**BAKERSFIELD CITY SCHOOL DISTRICT
ROOSEVELT ELEMENTARY SCHOOL MODERNIZATION
BAKERSFIELD, KERN COUNTY, CALIFORNIA**

Job No. 1317
Appl. No. 15-6
File No. 03-122920

ADDENDUM NO. #03

PARTIAL PLUMBING PLAN

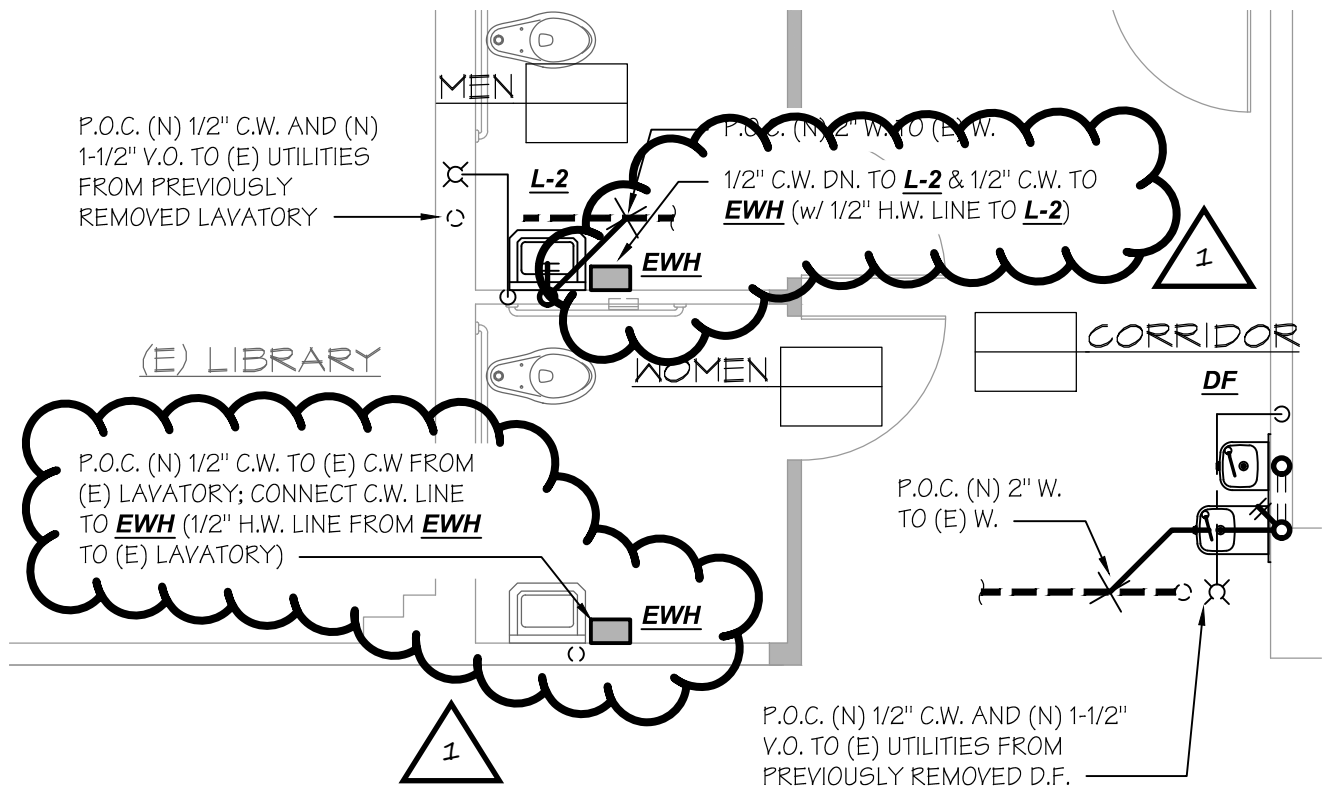
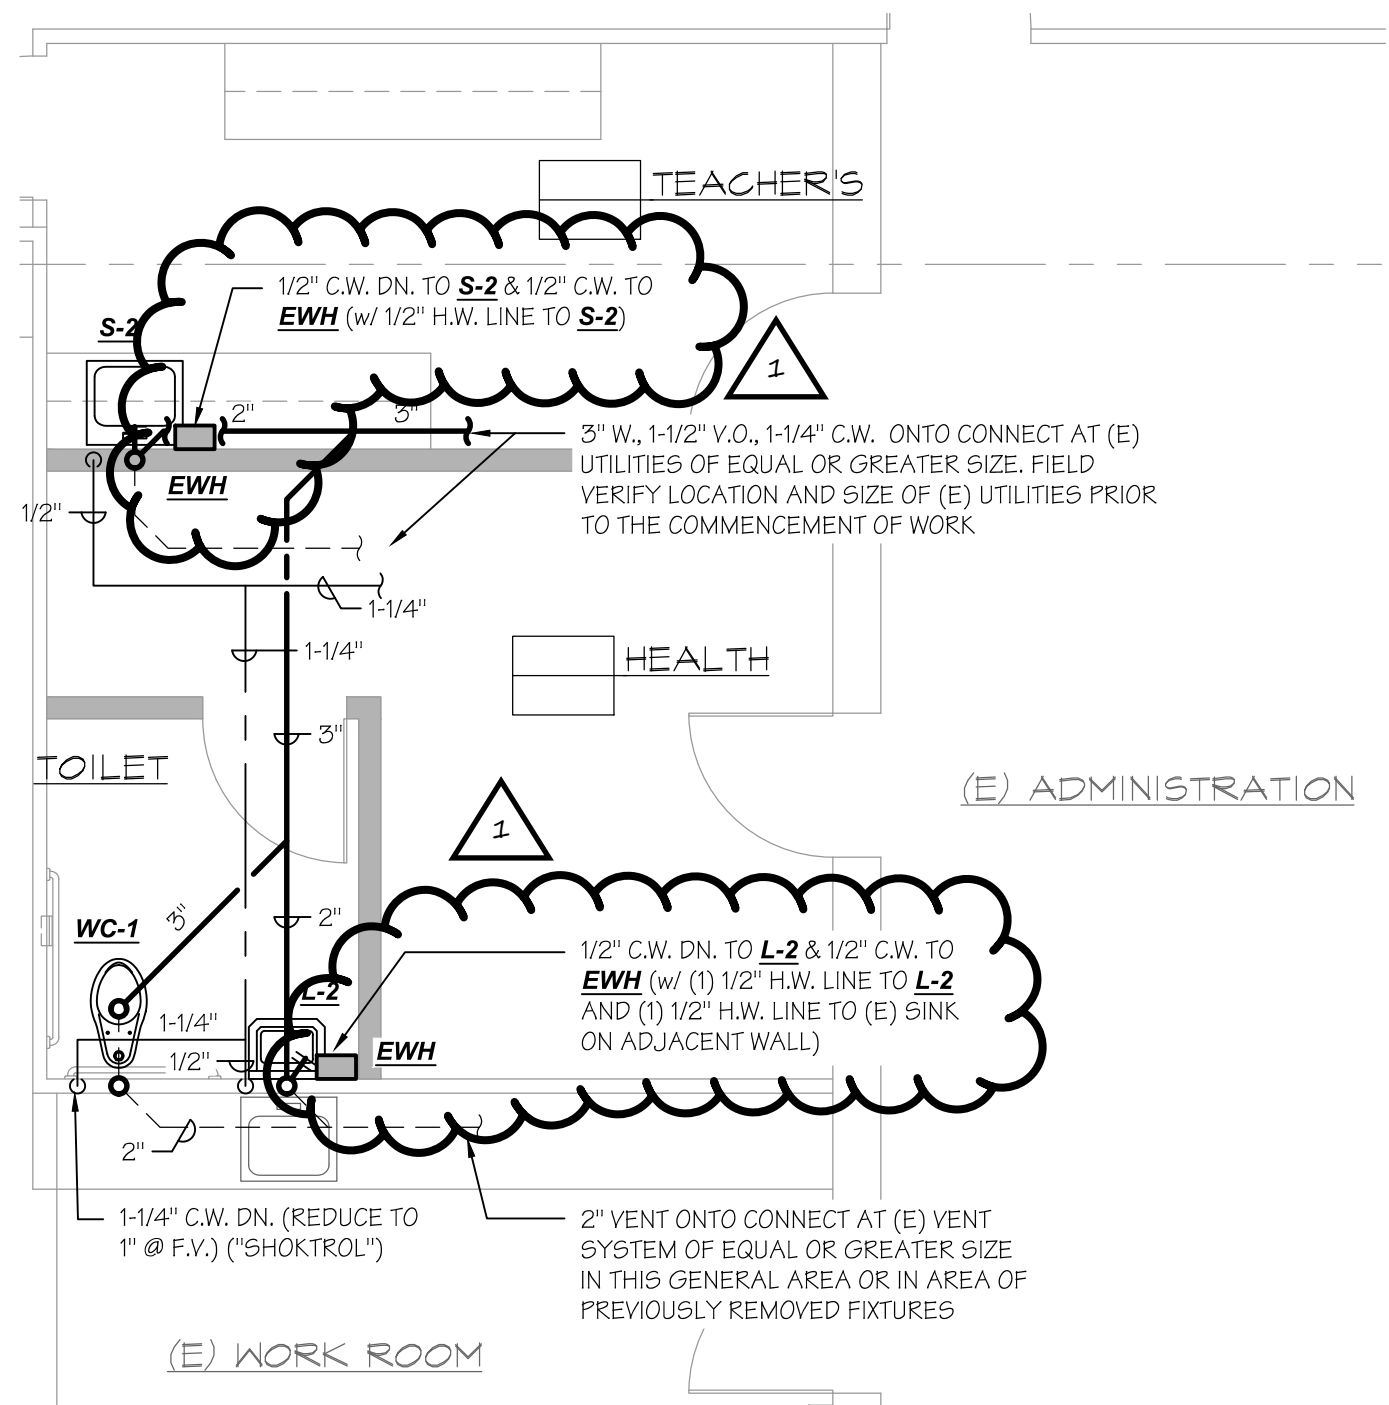
- 3-4) Refer to DSA Approved Drawings, Sheet No. P2.0 PLUMBING PLAN & DEMO PLAN BUILDING 'A';
- a. ADD: To DEMO PLAN BUILDING 'A', demolition of (E) service sink and water heater as indicated per attached Drawing No. 01.

- b. ADD: To PLUMBING PLAN BUILDING 'A', EWH to LAV's at Rooms 102 Toilet, 103 Teacher's, 104 Toilet and 105 Toilet as indicated per attached Drawing No. 02. See also Item 3-5 of this Addendum.

1 ADD EWH'S

ITEM • 3-4)b

PARTIAL POWER FLOOR PLAN

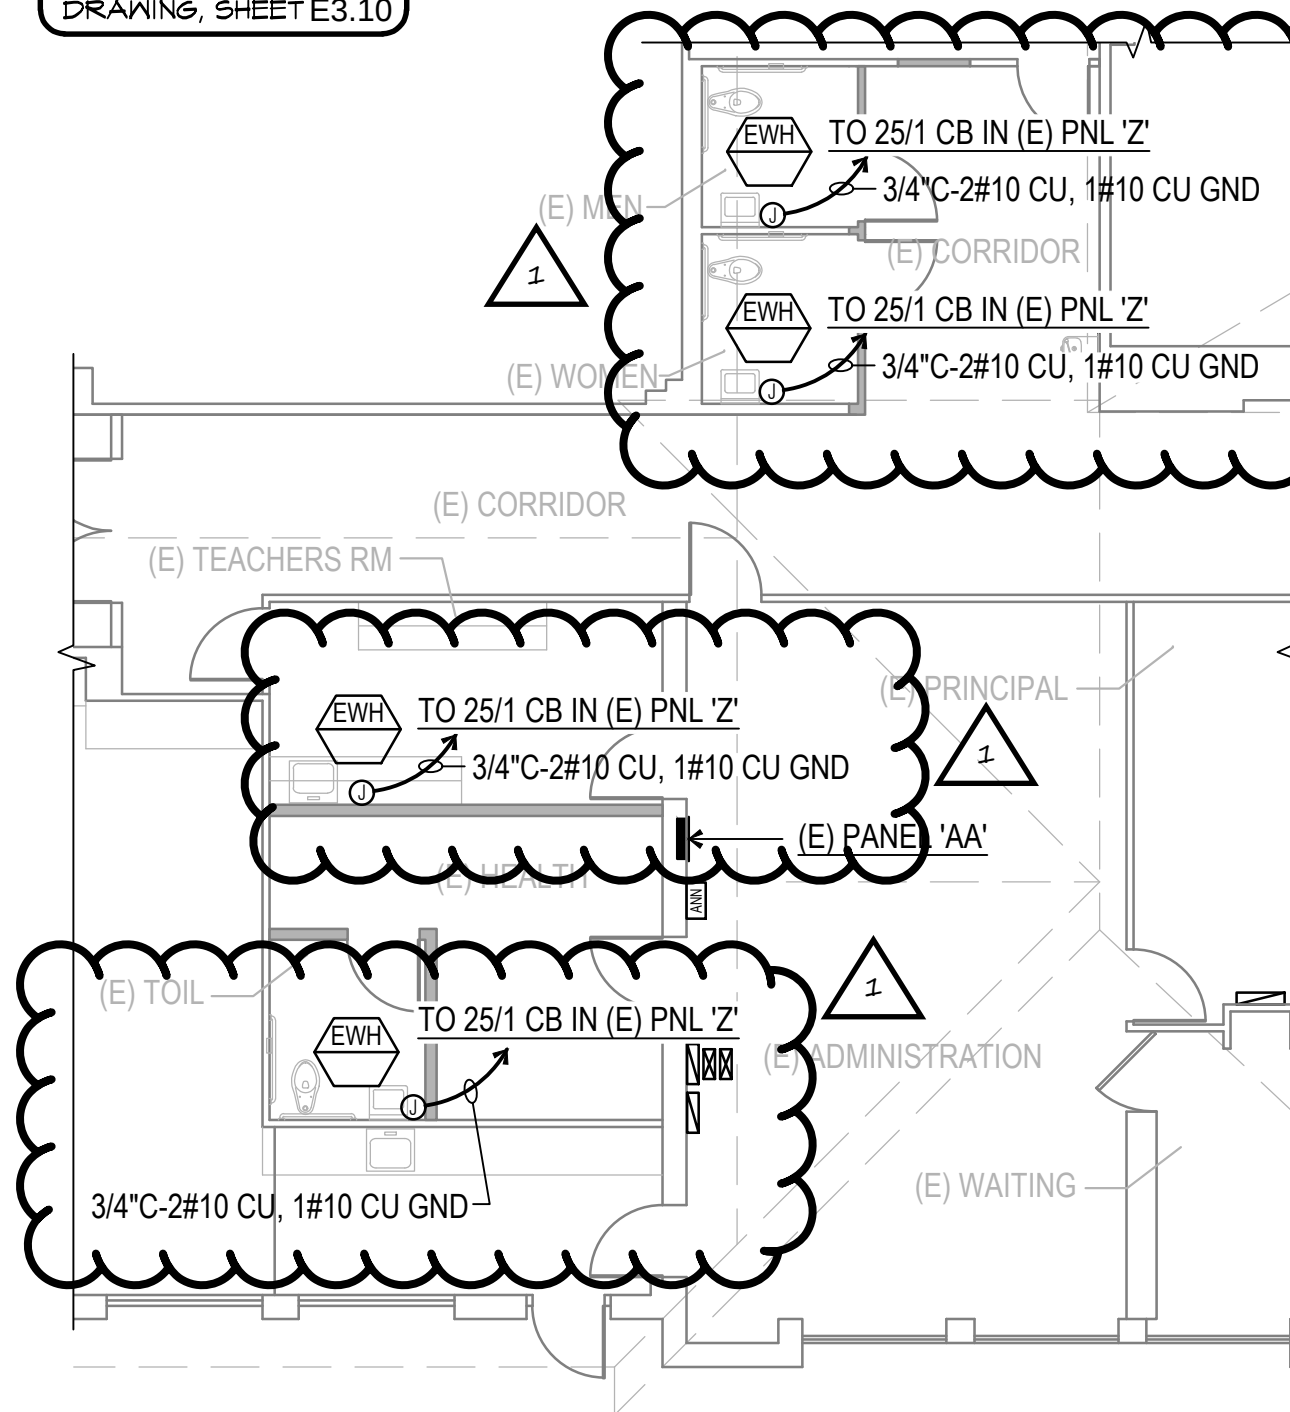
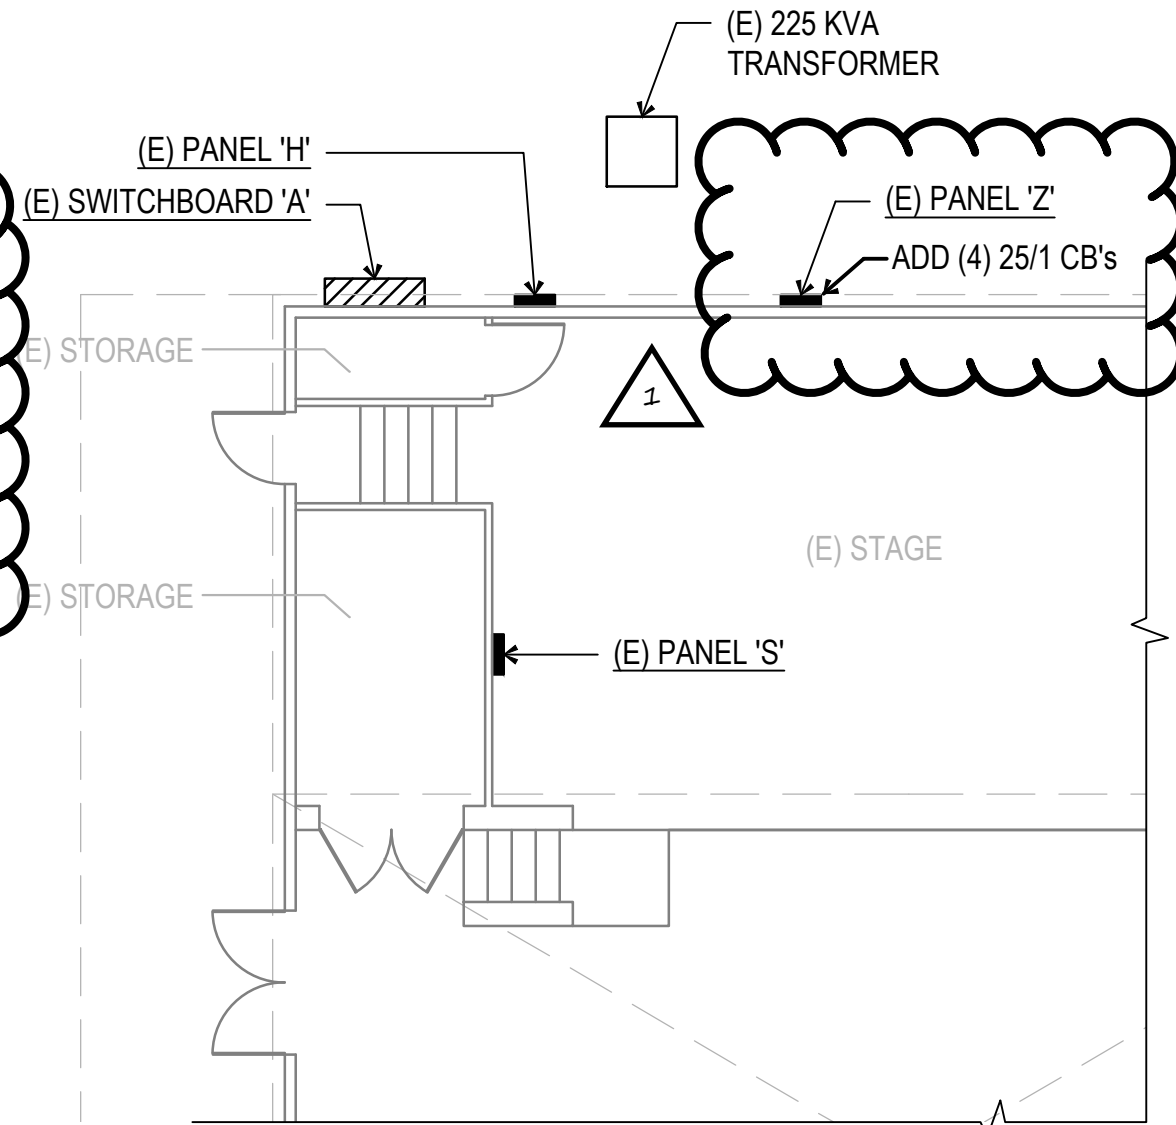
- 3-5) Refer to DSA Approved Drawings, Sheet No. E3.10 BLDGS A & E POWER AND DEMO FLOOR PLANS, POWER FLOOR PLAN BUILDING 'A';
- a. ADD: Power for EWH's as indicated per attached Drawing No. 03. See also item 3-4 of this Addendum.
- 3-6) Refer to DSA Approved Specifications, INDEX, DIVISION 09 FINISHES;
- a. ADD: Section 09 72 16 VINYL FACED WALLBOARD as attached to this Addendum.
- 3-7) Pre-Bid Questions and Responses;
- a. ADD: Pre-Bid RFI Nos. 001, 002, 003, 004, 005, 006 and 007 with responses as attached to this Addendum.
- 3-8) Refer to DSA Approved Drawing No. E1.00 ELECTRICAL SITE PLAN, SYMBOL LEGEND, DETAILS AND NOTES, ELECTRICAL SYMBOL SCHEDULE, SYMBOL FOR COMMUNICATIONS/DATA OUTLET, DESCRIPTION;
- a. DELETE: (1) Data Cable, (1) Voice Cable with Jacks.
Note: Box, gang extension ring and conduits with pull string shall remain as a part of this bid.

1 POWER FOR EWH'S

ITEM • 3-5)b
REF. DSA APPROVED
DRAWING, SHEET E3.10
